UNITED STATES PATENT AND TRADEMARK OFFICE

Office Action Summary

10/553,131

DETAILED ACTION

(fig. 2 of Gallup)

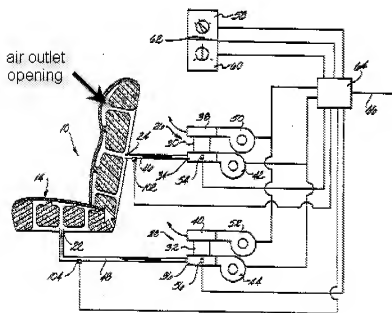
Regarding claim 8, an air supply device (fig. 2) for an automotive seat comprising: an air duct 46, which is arranged at the delivery side of a fan 42 and has at least one air outlet opening (see paragraph below where the examiner labeled originally not labeled elements with darkened arrow)provided in the upper region of the seat for supplying the head, shoulder and neck region of a seat occupant 12 with a flow of air, a heating element 34 arranged in the air duct between the fan and the air outlet opening, and at least one sensor 102 for detecting a parameter value as a function of which the flow of air emerging from the air outlet opening is controlled, wherein the sensor is arranged inside the air duct between (fig. 2) the air outlet opening and the heating element.

Regarding claim 12, wherein the grating element is arranged close to the air outlet opening of the air duct (fig. 2).

4. Examiner labeled originally not labeled elements with darkened arrow.

Regarding Applicant's argument that that fan 42 is not disposed in the lower end of the air supply device, the examiner disagrees. As shown in figure 2, fan 42 is disposed at the lower end of the air device 42, 34, 42. As is clearly shown in figure 2, fan 42 is on the lower end of said air device.

(fig. 2 of Brand)

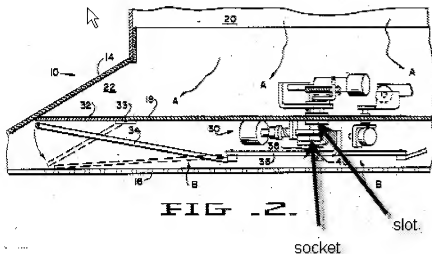
Brand teaches the sensor 30 (fig. 2) having a socket part (see paragraph below where the examiner labeled originally not labeled elements with darkened arrow) located in a slot (see paragraph below where the examiner labeled originally not labeled elements with darkened arrow).

It would have been obvious to one of ordinary skill in the art at the time of the invention to have the Gallup in view of Wallman invention modified with the Brand sensor socket located in the slot in order to attach the sensor to the duct.
